ADDENDUM NO. 02

COLTON MIDDLE SCHOOL – INTERIM HOUSING

DSA #04-124403

RCA Project No. 1-15-118

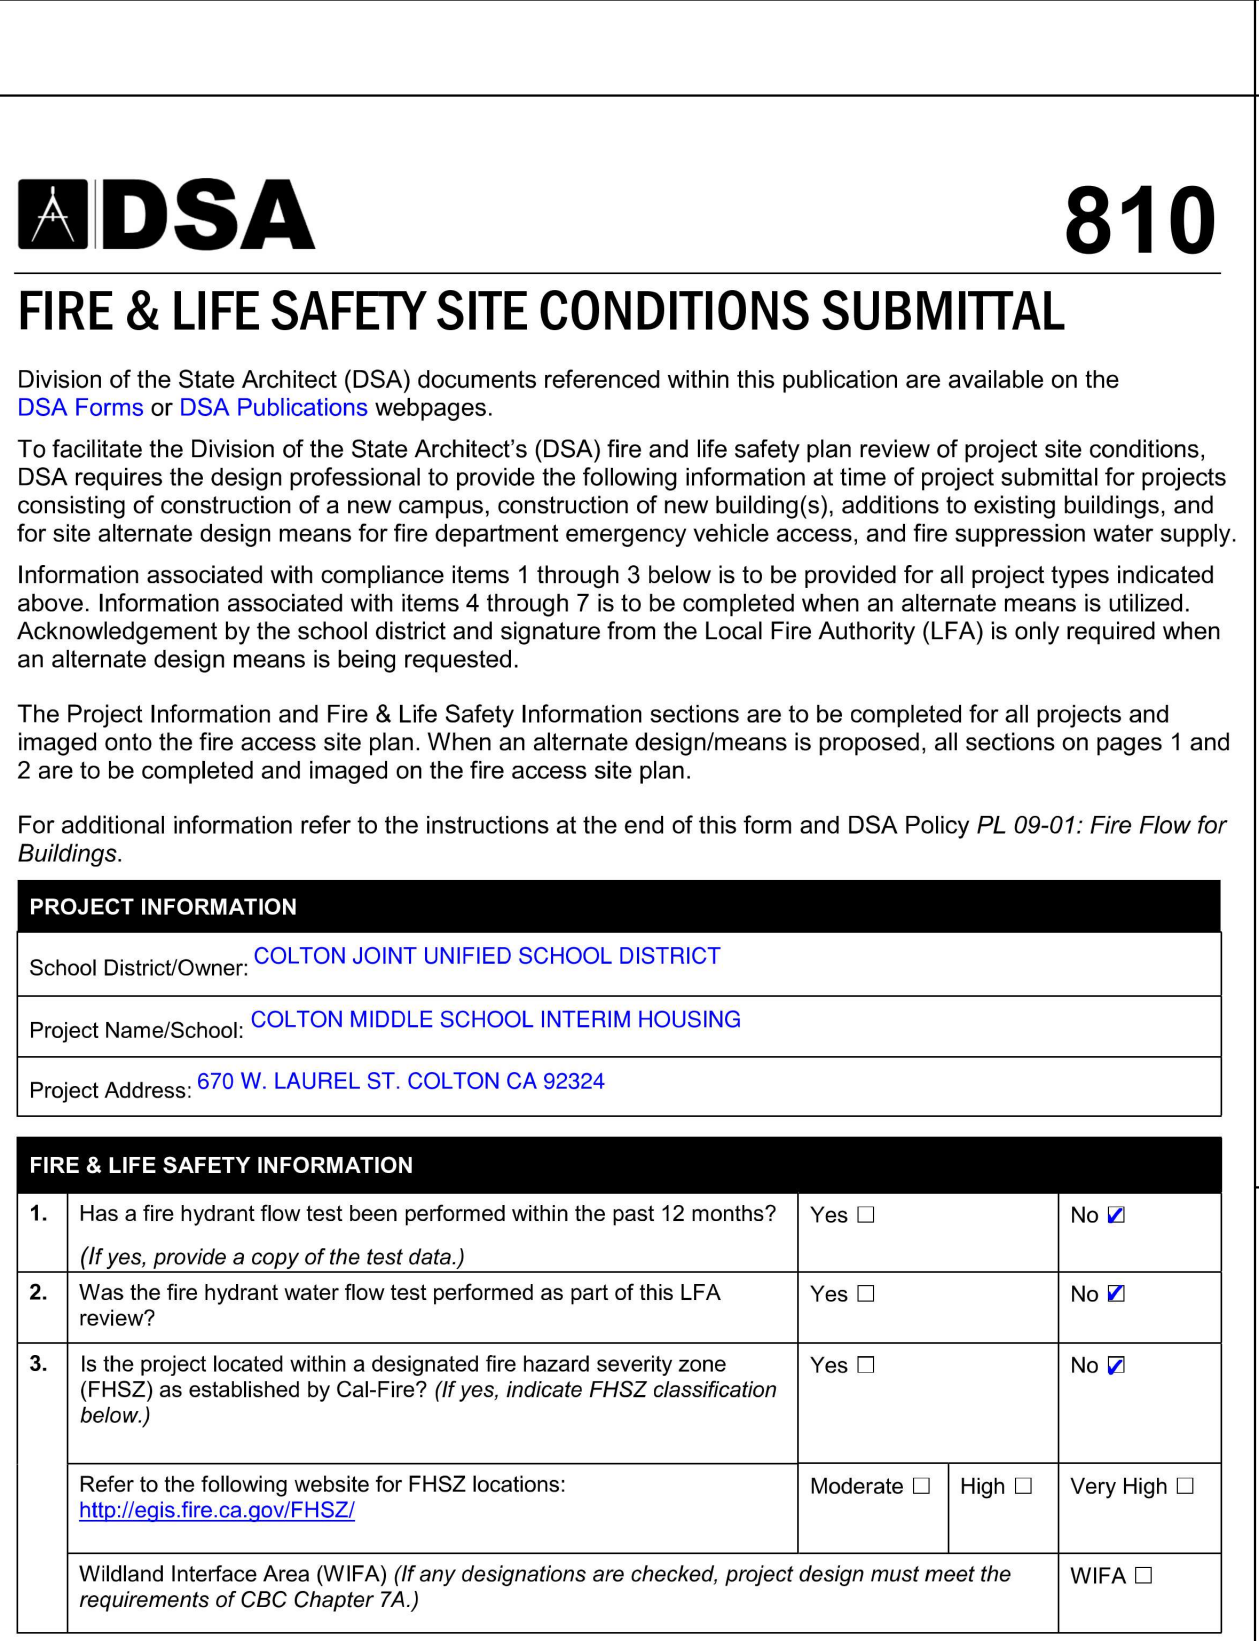
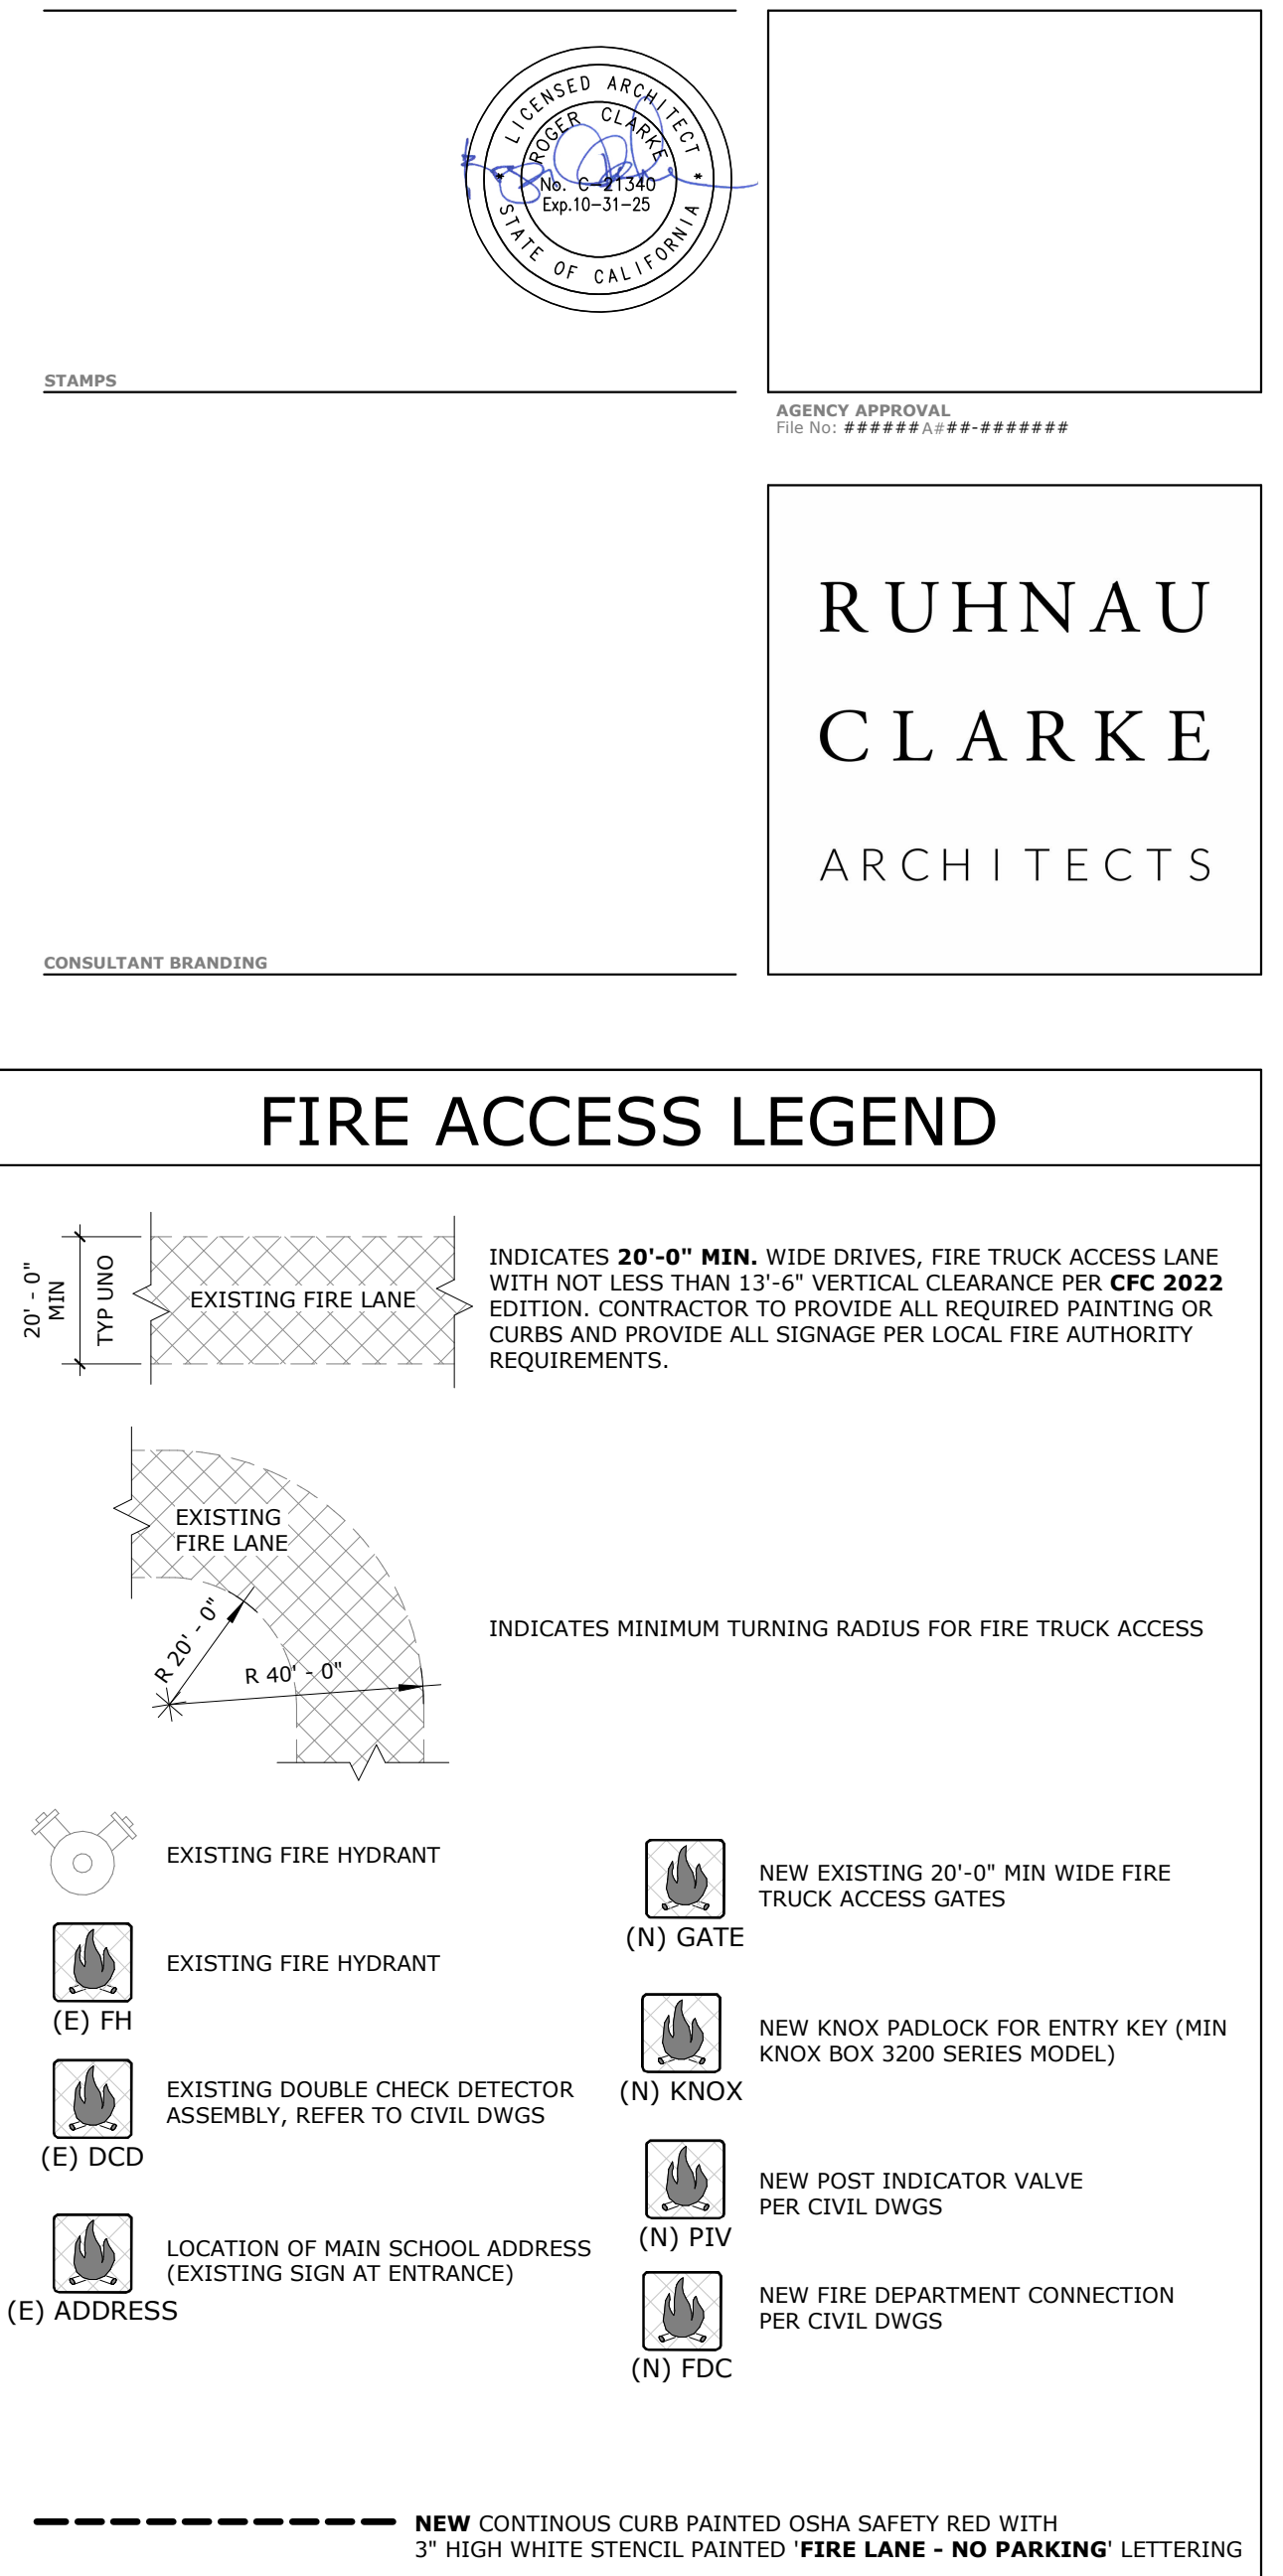
- Item No 2.1 Reference Sheet G-1 – Title Sheet & Sheet Index
 - 2.1.1 Removed sheet F3.01 and F3.11 from to Modtech drawings
 - 2.1.2 Added sheets F1.02 and F1.21 from Modtech drawings
 - 2.1.3 Revised Scope of Work narrative to show portable units N and P as OFOI.
- Item No 2.2 Reference Sheet AS-1.0 – Fire Access Site Plan
 - 2.2.1 Revised restroom at Portable P to match Silvercreek Modular drawings
- Item No 2.3 Reference Sheet AS-1.1 – Overall Site Plan & Code Analysis
 - 2.3.1 Revised restroom at Portable P to match Silvercreek Modular drawings
- Item No 2.4 Reference Sheet AS-1.3 – Enlarged Site Plan at Parking Lot Mod
 - 2.4.1 Revised restroom at Portable P to match Silvercreek Modular drawings
 - 2.4.2 Revised keynote 32.33.16.1 ramp to OFOI
- Item No. 2.5 Reference Sheet E-0.2 – Electrical Schedules
